TOWN OF EAST HAMPTON  
Planning and Zoning Commission  
1-860-267-7450  
www.easthamptonct.gov

PROJECT NAME Hampton Village

# HOUSING OPPORTUNITY DEVELOPMENT SUBDIVISION HAMPTON VILLAGE

## 37 SOUTH MAIN STREET EAST HAMPTON, CONNECTICUT

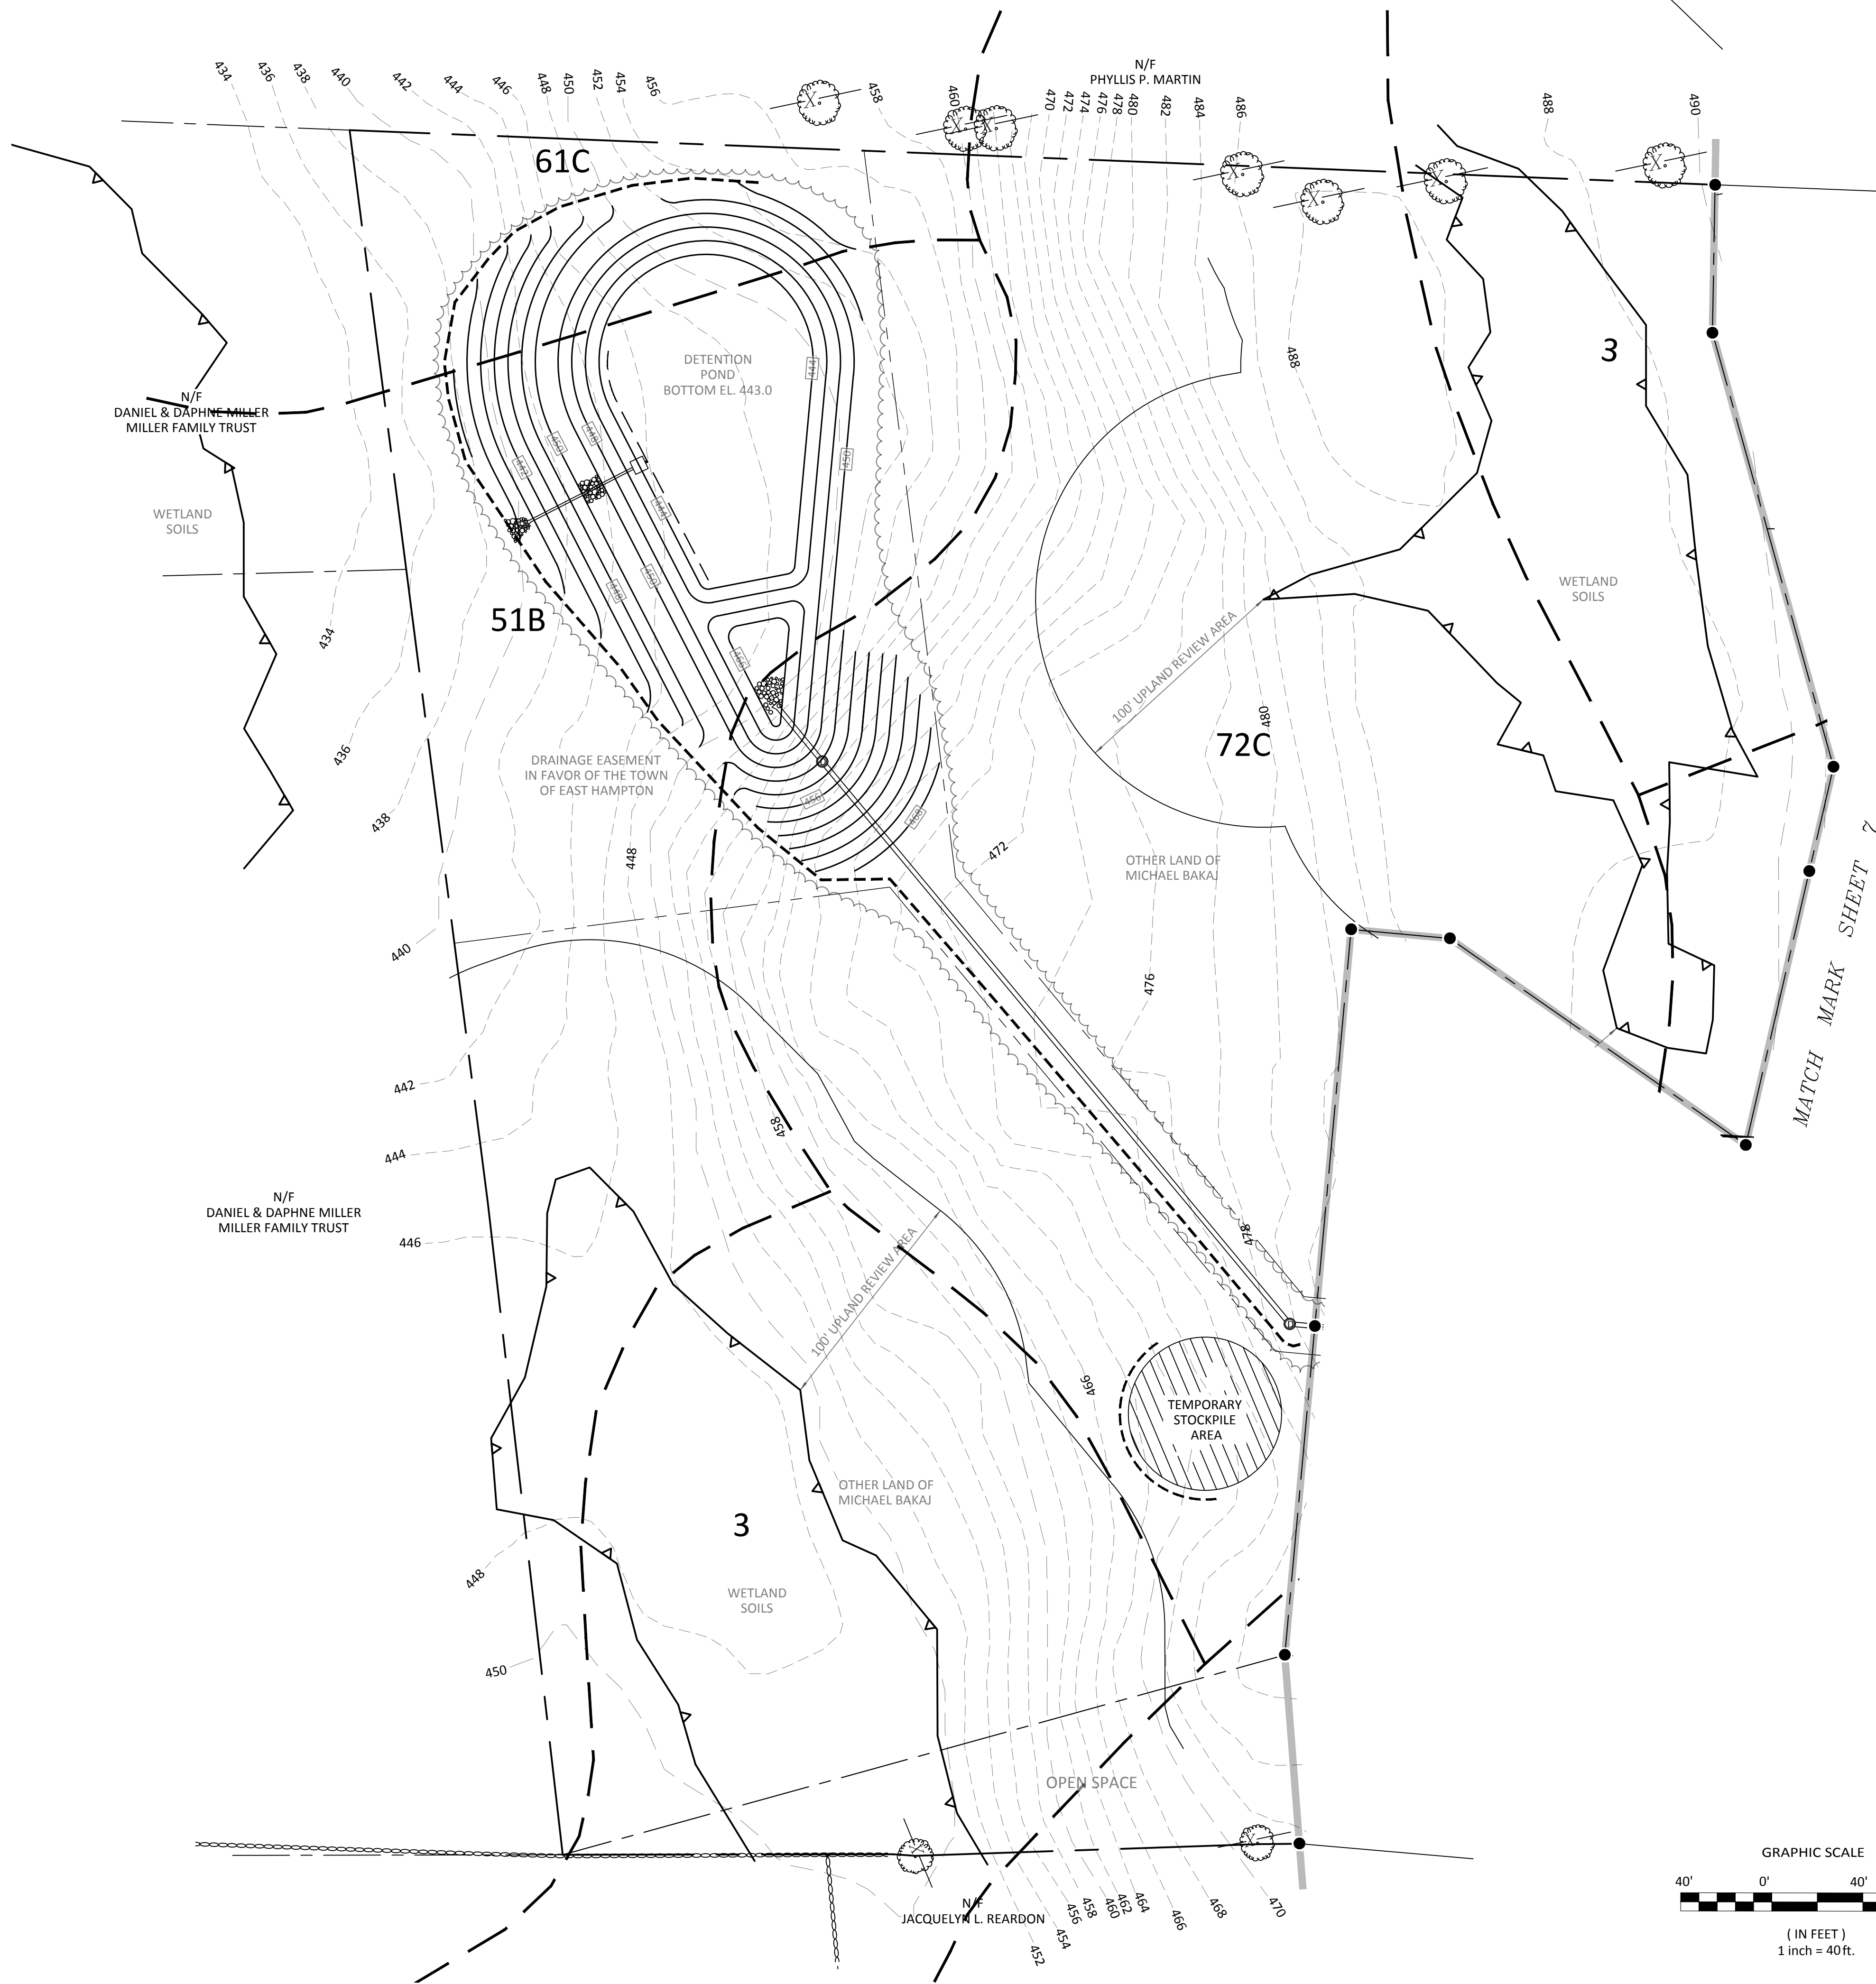
1. Erosion control fencing needs to be included down-gradient of the area where the stormwater pipe will be installed between the two cul-de-sacs.
2. A temporary soil stockpile is shown on sheet 8 as being outside the limits of clearing. Please either change the limits of clearing, or relocate the stockpile area.

5. Sheet 12 includes a detail for stone barriers, however, no stone barriers appear on the plan.
6. On Sheet 8, the bottom elevation of the stormwater basin is shown to be 443. However, on sheet 11, the profile indicates the bottom of the basin lies at elevation 465. This discrepancy is throughout, including top of berm, etc. Drainage manholes include a similar discrepancy between pages 8 and 11. Please rectify.

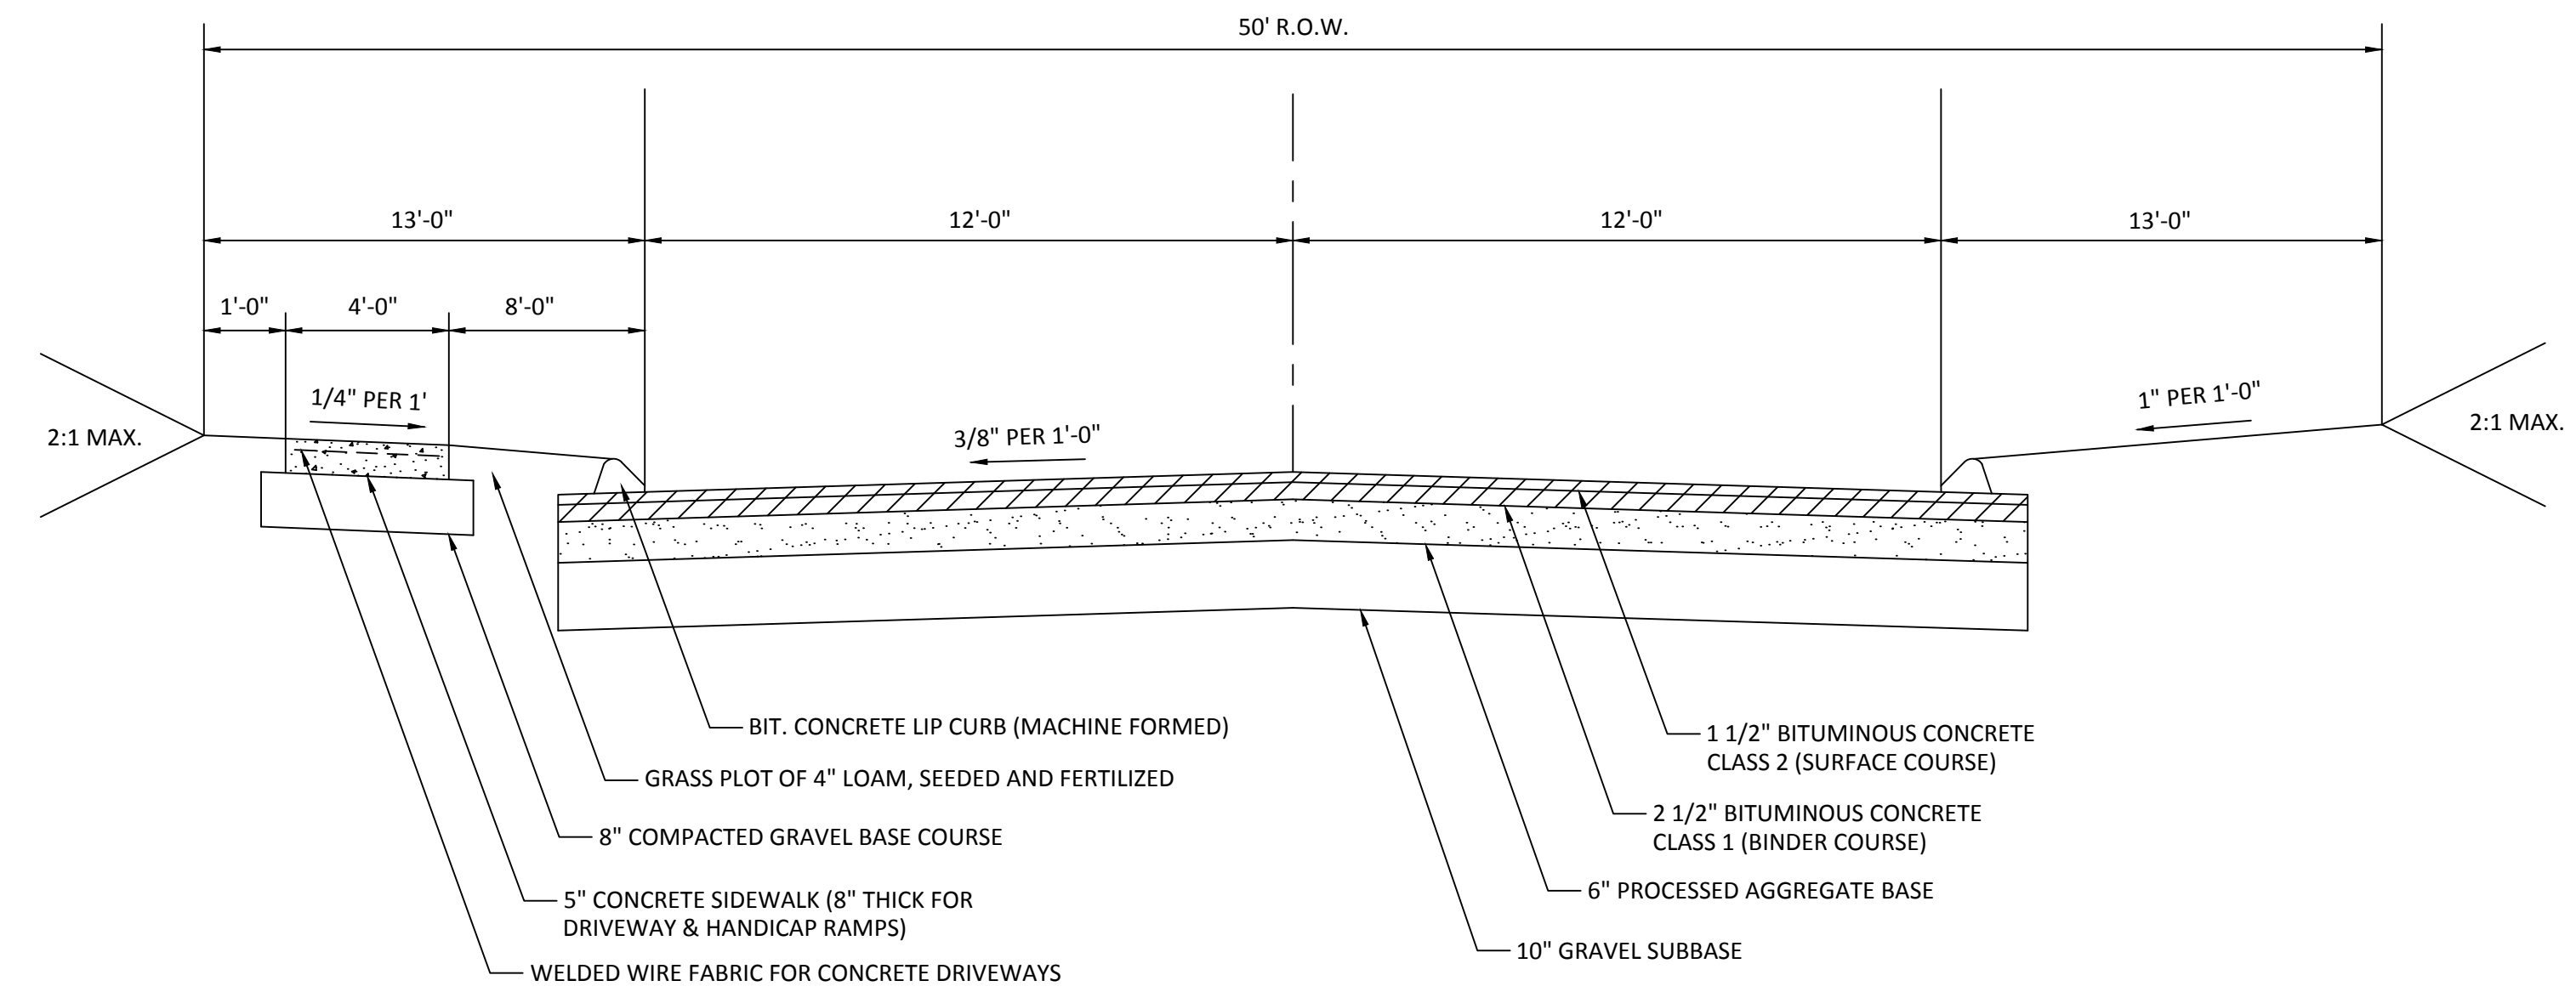
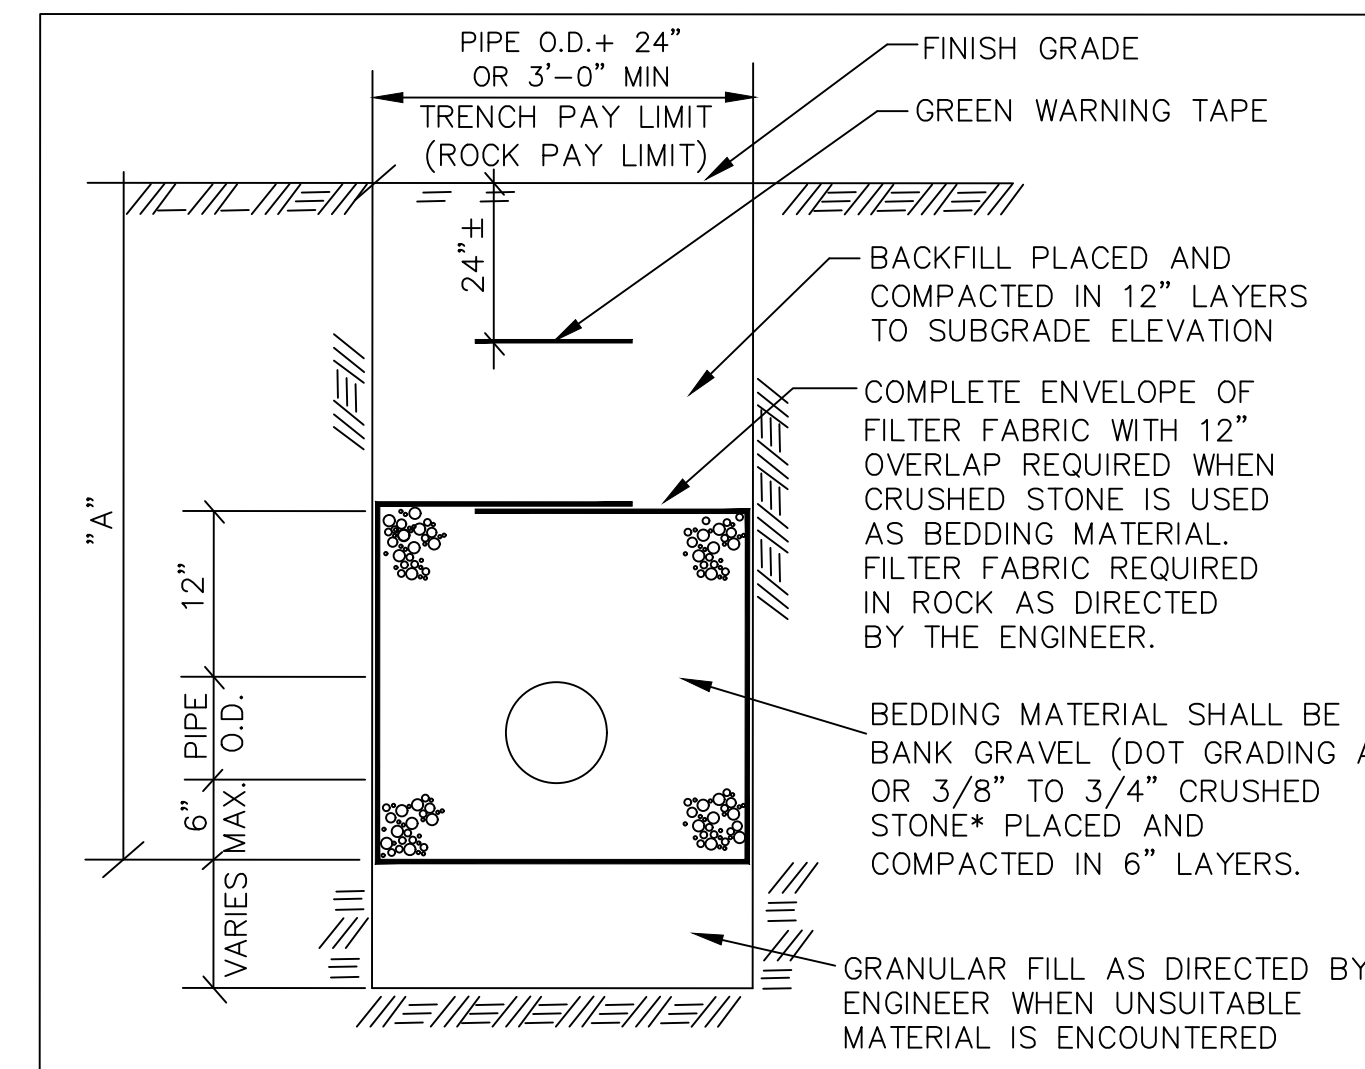
7. The development schedule on sheet 12 indicates a construction schedule beginning in fall 2020. Please revise.
8. Please show sight line distances at the intersection of the new proposed road and South Main Street.

3. The General Erosion and Sedimentation Control notes on sheet 12 indicate that a third party will be retained to monitor conditions during construction. Please provide contact information for the proposed third party.

4. The General Erosion and Sedimentation Control notes on sheet 12 reference check dams to control turbid water during construction. No check dams are present on the plans.
